1993 Corvette: Service Bulletin: Hood Will Not Open - Cable Disconnection

Subject: HOOD WILL NOT OPEN, CABLE DISCONNECTED

Model and Year: 1993 Corvette prior to V.I.N.'s: Non-ZR1 - P5110787 ZR1 - P5800217

Bulletin Number: 93-151-10

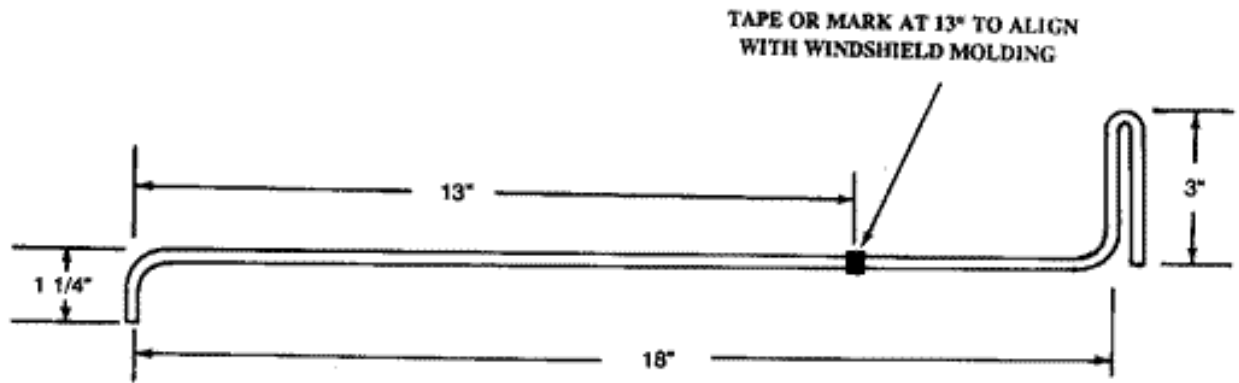
The hood release cable may become disengaged from the hood latch lever.

NOTE: It is possible that one or both of the latches may have disengaged cables.

Replace the hood latches with service P/N's 10210747 (Left) and 10210748 (Right)

TOOL

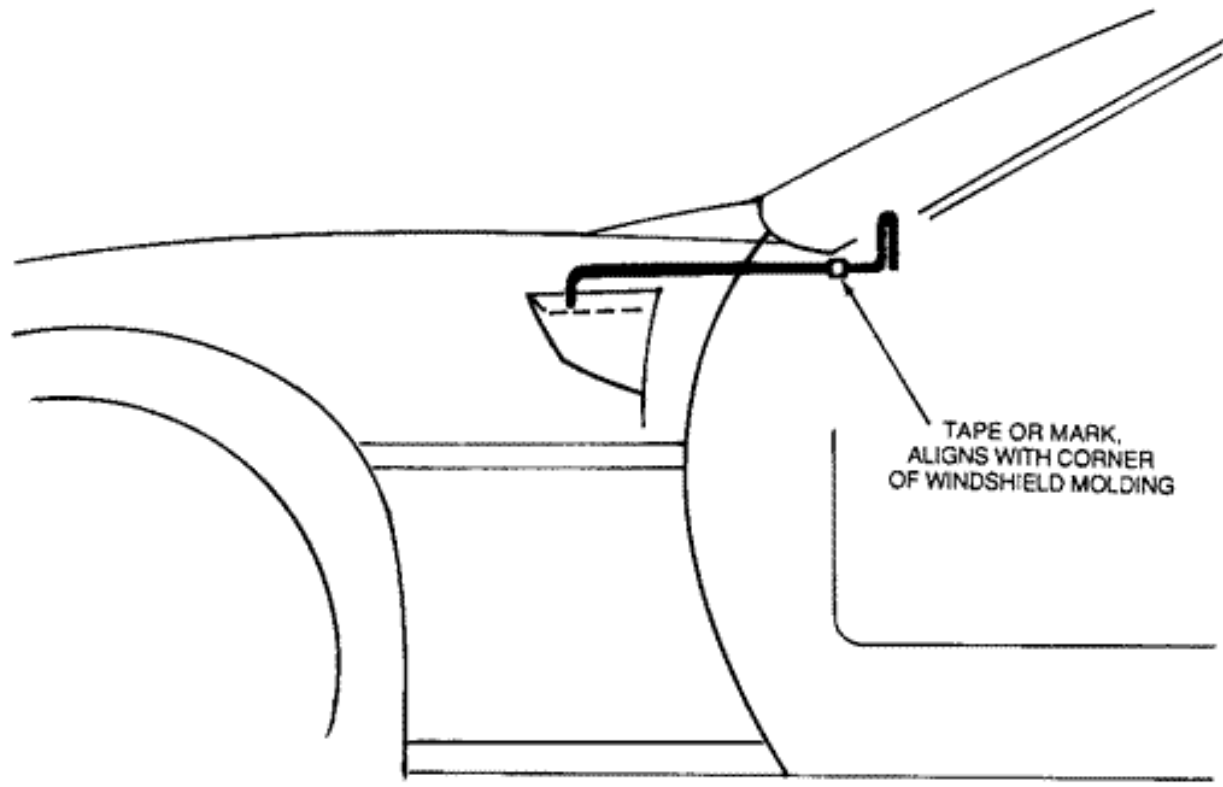
NOTE: Opening the hood will require the following:

- Obtain material locally and fabricate the tool shown on the illustration from 3/16" or 1/4" steel rod.
- With the door open, locate the short bent end of the tool inboard of the vertical flange of the hood latch support.
- insert the tool forward until the tape is aligned with the lower end of the windshield pillar molding.
- Twist the tool to contact and move the latch lever until the latch disengages. A slight downward pressure on the hood in the latch area may be helpful to disengage the latch lever.
